**City of Ramsey**  
**Agenda**  
**Environmental Policy Board (EPB)**  
**Monday, August 16, 2021**  
**6:30 pm**  
**Council Chambers, 7550 Sunwood Drive NW**

Consider Natural Resources Aspects of Site Plan and Plat for G-Will Liquors

**NORTH BROOK  
MEADOWS**  
 RAMSEY, MINNESOTA

**TREE PRESERVATION PLAN**  
**L1.1**

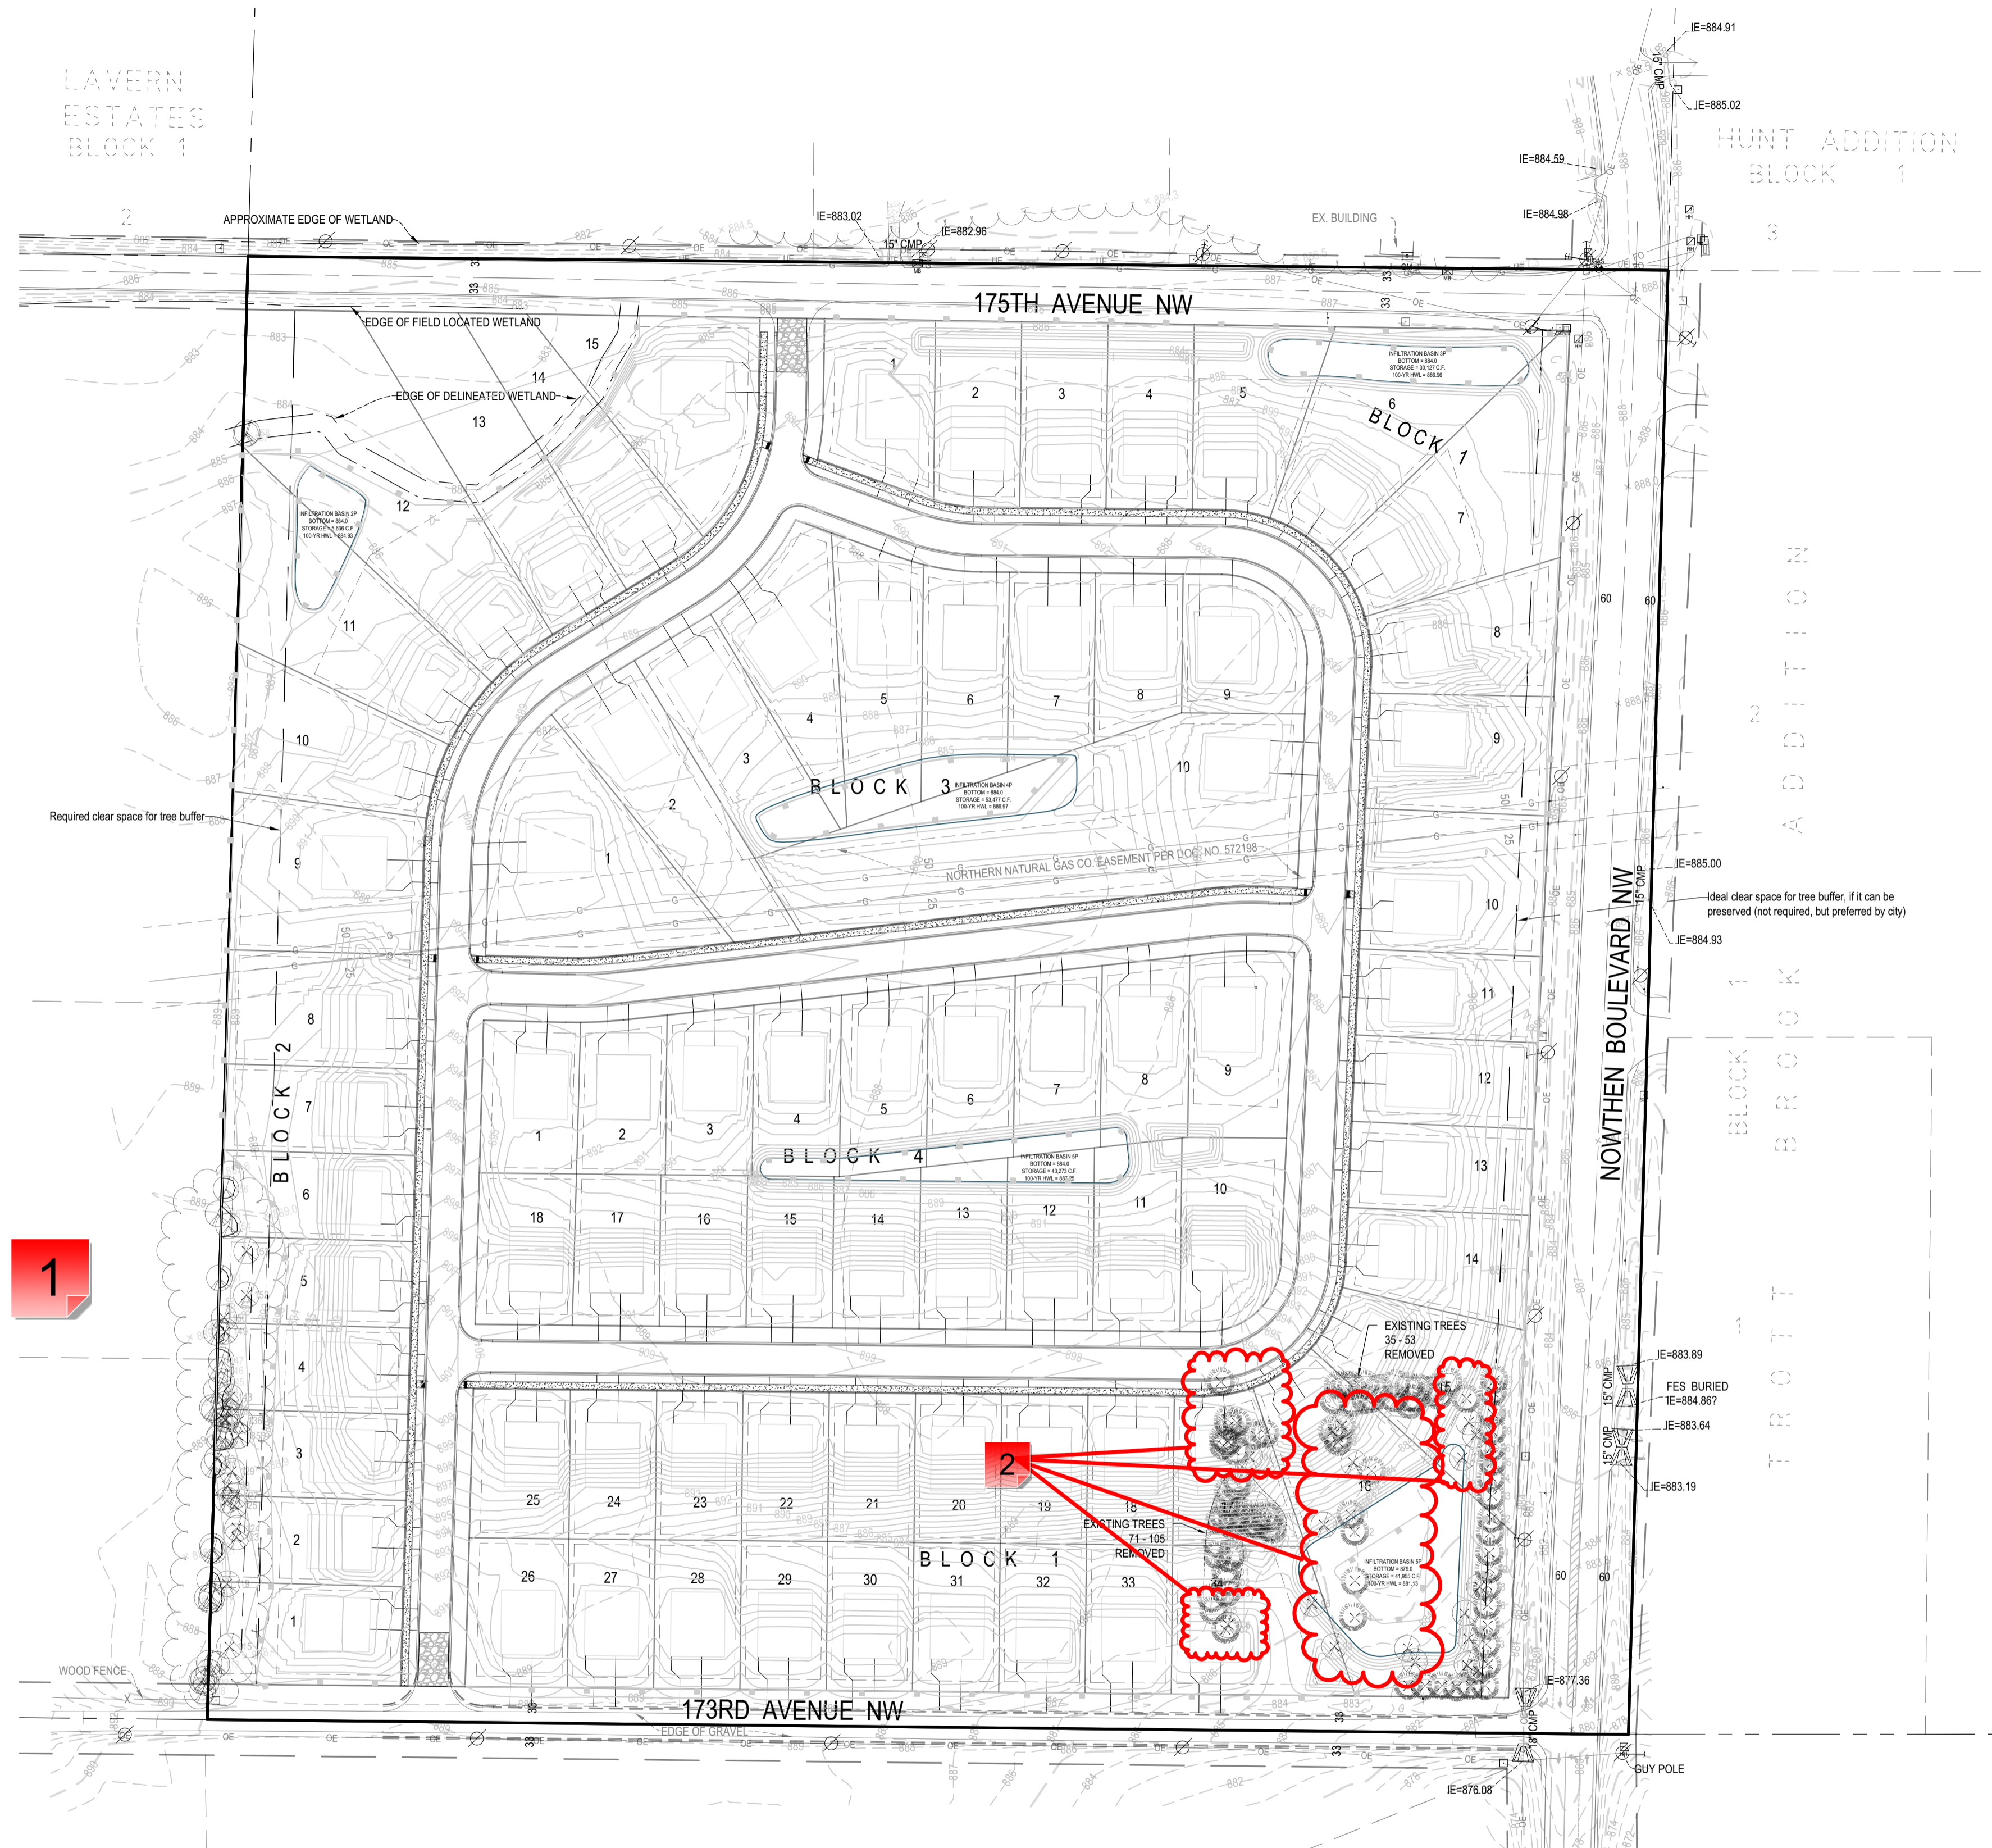
Please provide a summary tally of total significant DBH inches on site, # of inches proposed to be removed, # of inches proposed to be saved, and # of inches exempt from calculation (e.g. invasive species, removed for stormwater ponds, etc.).

Change color of Tree ID #s to black to differentiate from the contour elevations.

It appears that all of these trees are going to be removed, based on grading, stormwater pond location, and house pad locations. Update sheet accordingly.

**LANDSCAPE PLAN**  
**L2.1**

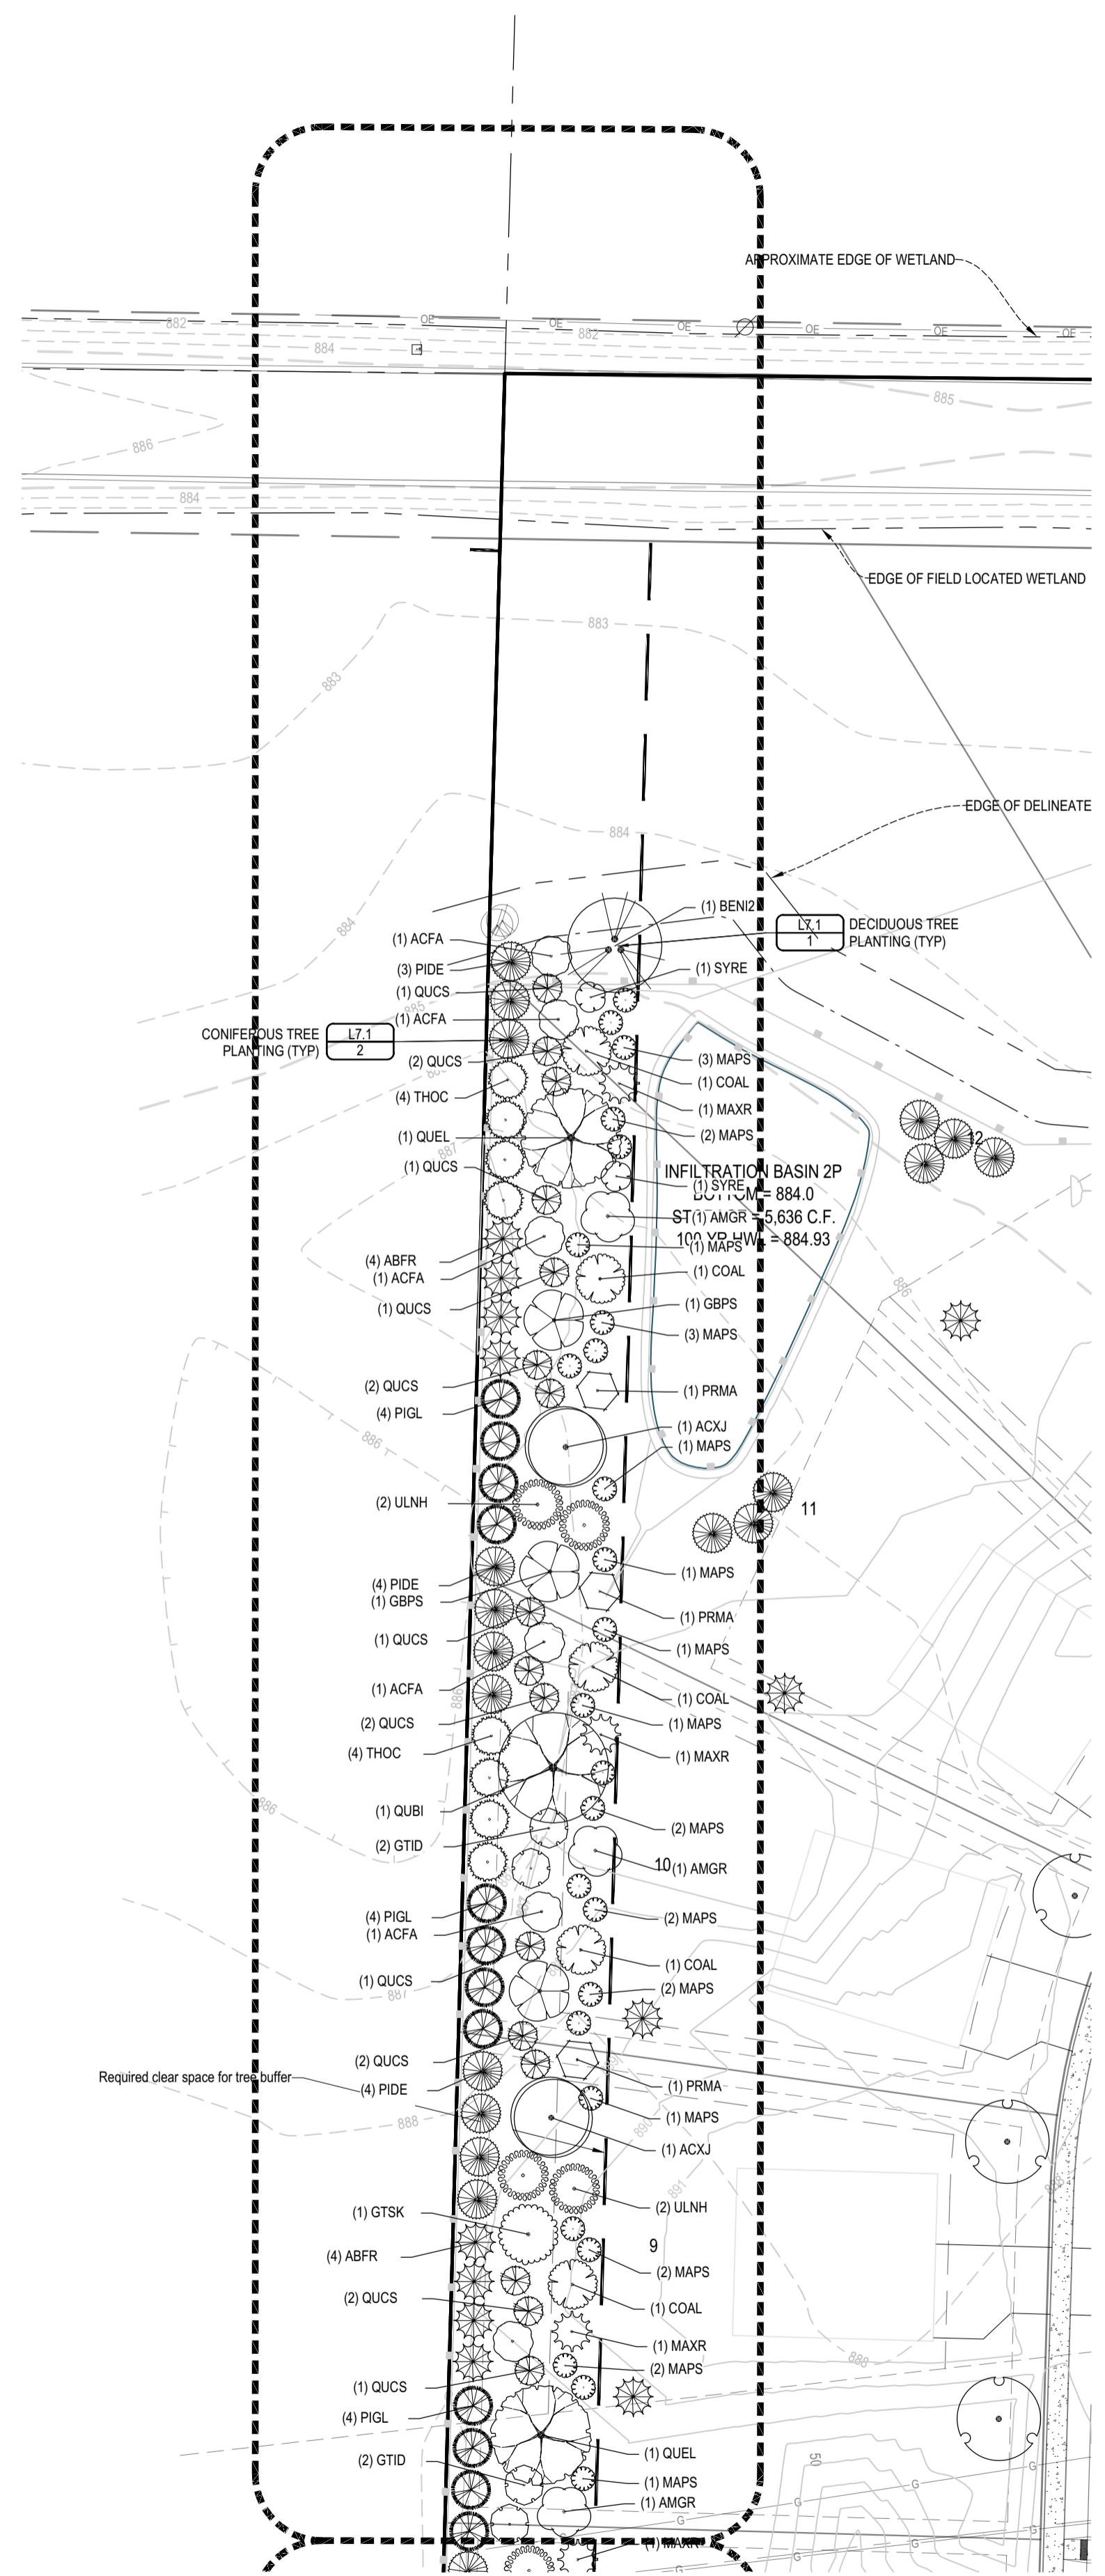
The R-1 Residential (MUSA) - 80 district requires 2 trees in planted in the boulevard and/or front yard. Update the plan to show both trees in the front yard, with, preferably, at least one tree in the boulevard per lot.

Need verification from Easement holder (appears to be Northern Natural Gas Company), whether any tree plantings would be permitted within easement area.
